product modification

045-0118-00

FIRMWARE UPDATE

836 Serial Numbers R010276 - R010353

Figure 2. Location of U235 on the Processor (A1) circuit board.

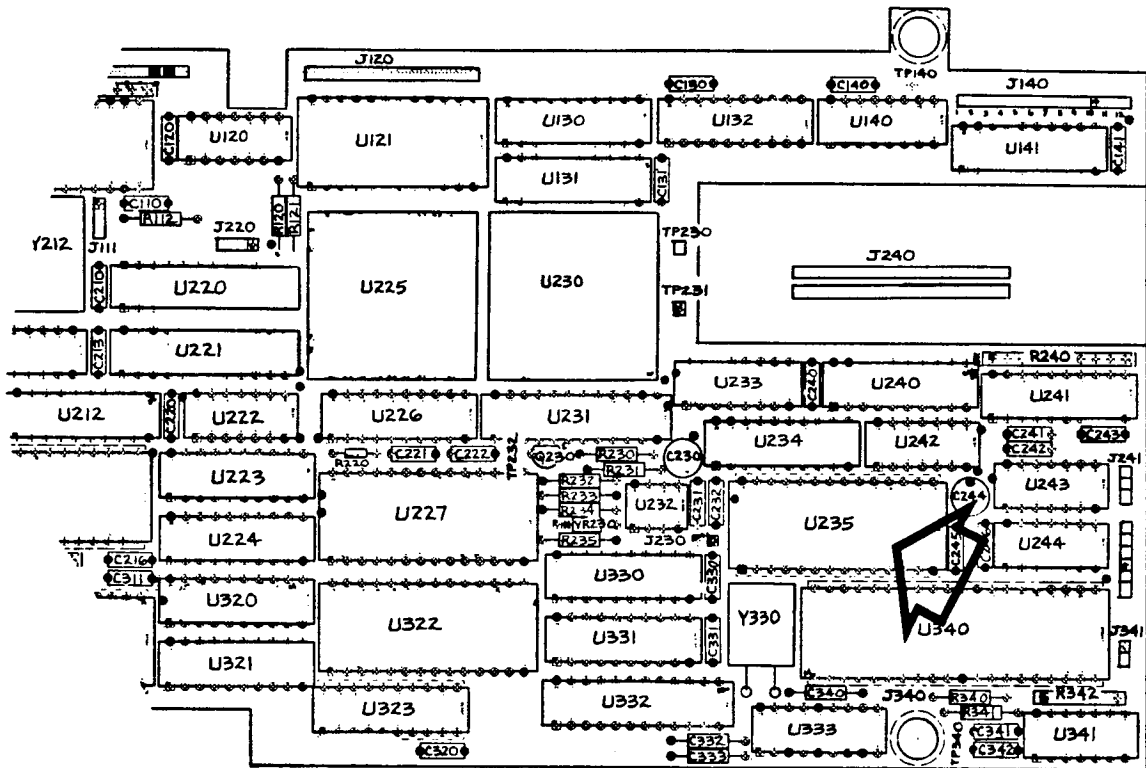
This product improvement kit provides firmware (U235) and installation instructions to eliminate errors encountered when using "1 A Transfer" function with 830 Series ROM Packs.

- () 2. On the Processor circuit board -- Replace U235 with microcircuit (pn 160-3352-05) provided in the kit. Refer to Figure 2 for location of U235.
- () 3. Reassemble the instrument, reversing disassembly procedure.
- () 4. Affix the identification label, provided in the kit, to the bottom cover (near the center cover-securing screw) to indicate this kit has been installed.
- () 5. For future reference, correct the Electrical Parts List in the Instruction Manual to reflect the change incorporated by this kit.
- () 6. Refer to the 835/836 Service Manual and perform the LIST-ROM TEST to verify the correct internal ROM has been installed as follows:
